Proposal for amendments to Regulation No. 79 (steering equipment) Requirements applicable to ACSF of Category C1

I. Proposal

Fig. 1

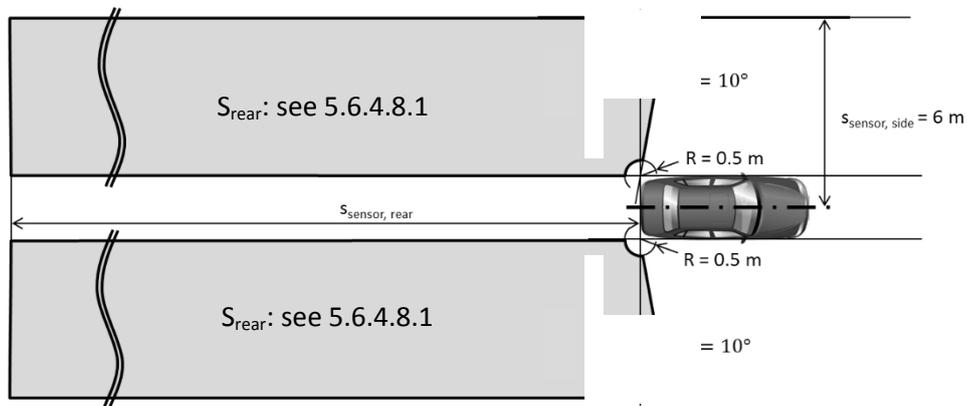
5.6.4.8.2. The vehicle system detection area on ground level shall be at minimum as shown in the figure below.
